Equinox Sub Division Stage 3 WWTP Upgrade
ASBR+80 CONV 133KL Sewage Treatment Plant
General Arrangement Drawing
Site Plan & Elevation Views

MAK6010-VA-001 - TWSe	GA Drawings - Site Plan / Container Section view to 133KL	A	07/03/2025	Issued for Client Review	TWSe	RW	TW	DM	All dimensions in mm	Scale: 1:100	Sheet 1 of 3
MAK6010-VJ-001/002/003	GA Drawings - P&ID / Site Isometric / Container Plan view	-	21/08/2023	Construction 80KL / COMPL.	-	RG	NJ	PF	Commercial in Confidence	Client Document No.:	Document No.:
Reference Drawing No.	Reference Drawing Title	Rev	Date	Description	Notes	DRN	CHK	APP	Paper Size: A3	-	MAK6010-VA-001 - TWSe
1	2	3	4	5	6	7	8	9	10	11	12

SECTION A-A

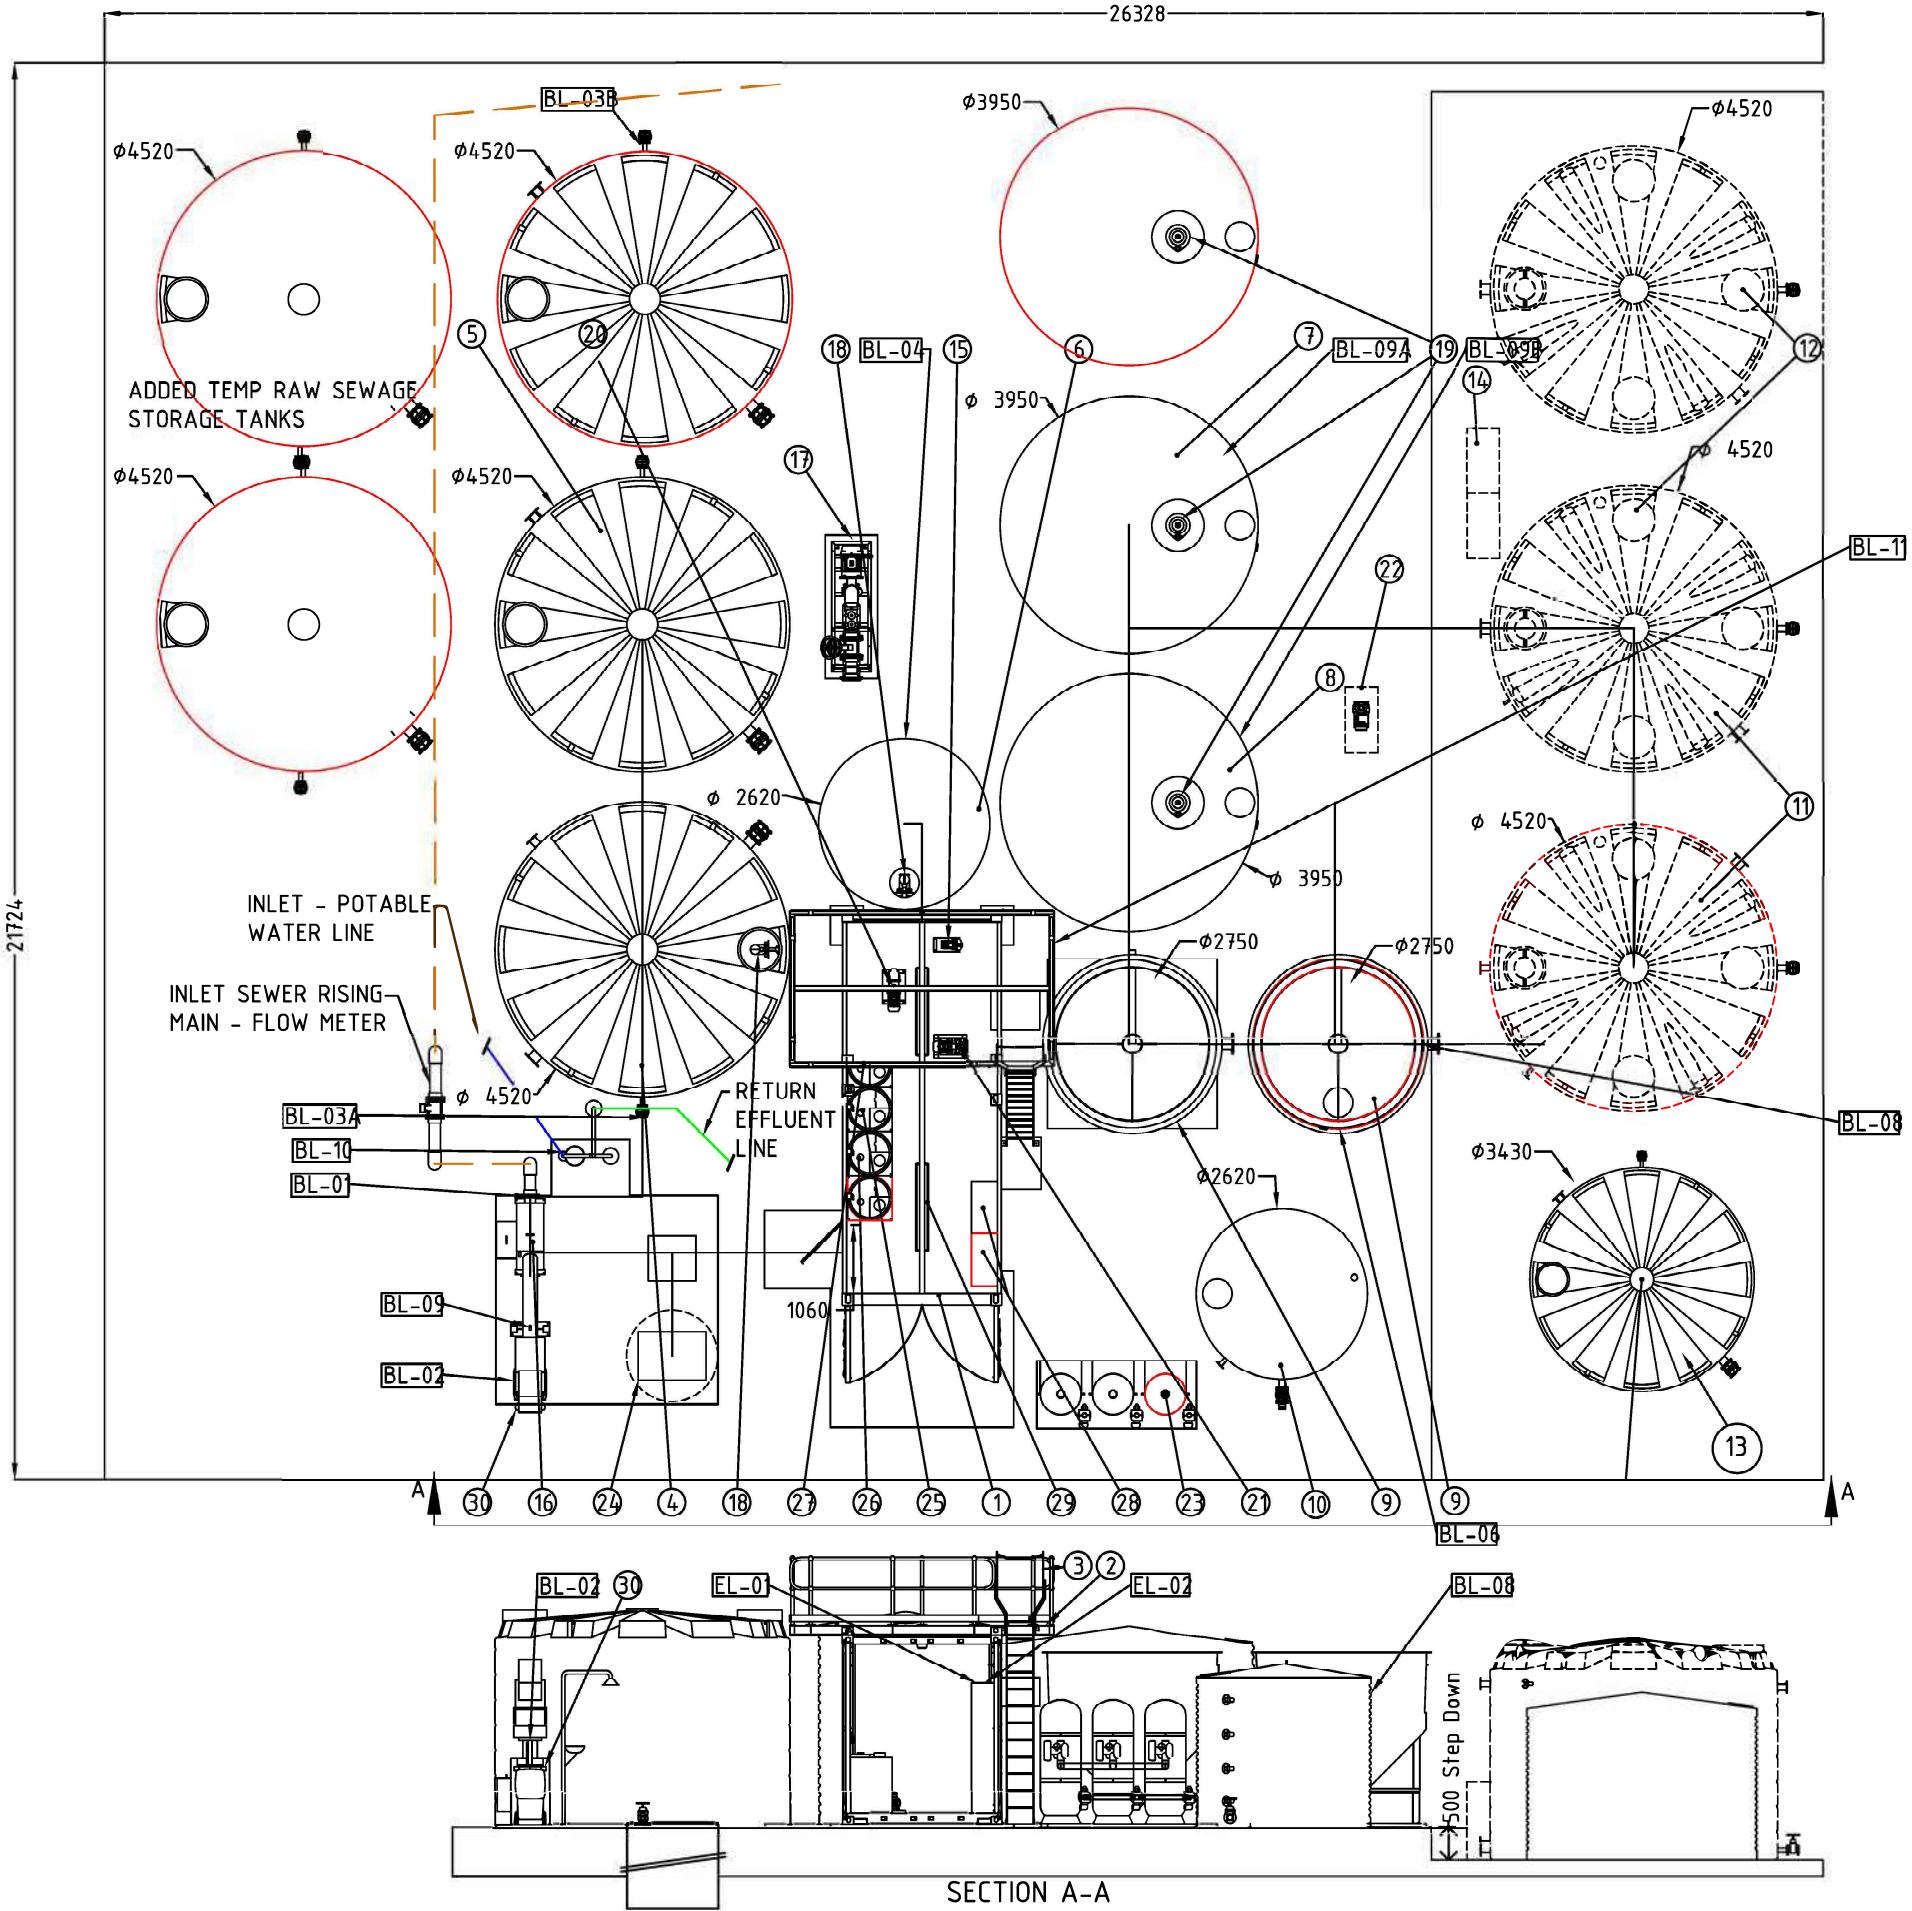
PLANT EQUIPMENT ADDED 'RED LINE' MARKUP
